REPORT TO: Committee of Adjustment

**REPORT NO.:** DSD-2025-349

SUBJECT: Minor Variance Application A2025-084 – 27 Turner Avenue

Figure 2 - Concept Site Plan – 27 Turner Avenue

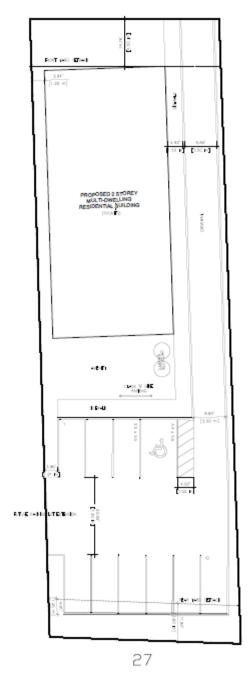
The intent of the parking lot setback is to ensure that there is appropriate separation from adjacent property lines and that appropriate landscaping can be maintained on the subject property. The side yard setback is appropriate for the development as the parking lot is proposed to extend onto adjacent properties once the next development commences. Appropriate rear yard setbacks are maintained and staff are satisfied the reduced setback is appropriate and meets the general intent of the Zoning By-law.

The intent of the parking requirements is to ensure that adequate parking is provided on site. Staff note that there is only one parking space provided per unit, however when the adjacent properties are developed additional parking spaces will be provided for visitor

parking. The lands also have access to multiple transit routes along Victoria Street and Frederick Street, as well on street parking is provided along Turner Avenue. Class A Bicycle storage will also be required and provided internal to the units and Class B Bicycle parking is shown on the site plan. Staff are satisfied the reduction in parking is appropriate for the development and meets the general intent of the Zoning By-law.

Transportation Services have reviewed this application and offer the following comments. Of the 10 proposed on-site parking spaces, 1 space is required to be designated for visitor use and must be clearly signed on-site. The remaining 9 spaces are to be allocated for tenant use.

The proposed driveway access width of 3 metres is considered acceptable for serving up to 10 units. However, if the development intensity increases (more units or additional vehicle traffic), the entire length of the access must be widened to support two-way vehicle traffic.
